SERVICE BULLETIN

SB1215

ADDRESSEES	: Owners and operators of coaches listed under 'Application'
COACH/BUS MODEL	: T2140, T2145, C2045 with following specification: 2004 engine, Allison Gen IV transmission, and Jake Brake
BULLETIN TYPE	: Service Information
SECTION/CHAPTER	: Section 3 – Drive train Chapter 6.2 – Transmission control systems
DATE	: January 18, 2008
SUBJECT	: Jake Brake - harsh engagement
TERMS & CONDITIONS	: Refer to the Warranty Information further in this Bulletin.

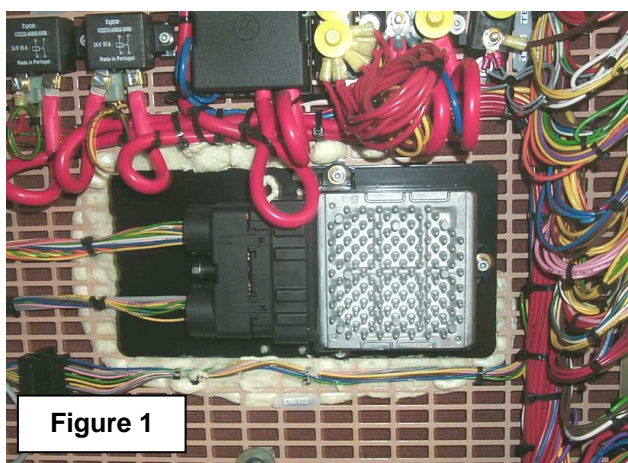
1. It has been determined that, with the transition from model B500 WTEC to model B500 Gen IV transmissions, Allison have introduced parameter changes in the Transmission Control Module (TCM – Figure 1, overleaf) that adversely affect the operation of the Jake Brake.
2. When the Jake Brake is activated on units that are equipped with an Allison B500 Gen IV transmission, the engine brake will cut-in in a much harsher fashion than would be the case on units equipped with an Allison B500 WTEC.
3. To address the issue, Allison will replace, at the customer's request and free of charge, the TCM of the above-mentioned units by a TCM that is programmed for more progressive Jake Brake operation. The terms and conditions for this repair have been outlined in the Warranty Information section of this Bulletin.

VH reference	Description	Qty.	Refer to
VH 11031164	TCM with calibration A43005VW	1	Figure 1

VH reference	Description	Qty.	Refer to
VH 11084837	TCM with calibration A4300A4T	1	Figure 1

- Old and new parts are interchangeable, but only the new will be offered as service replacements.
- Parts may be purchased from your nearest ABC Customer Care & Parts Source service center.
- Parts/Waste disposal: refer to the Warranty Information in this Bulletin.
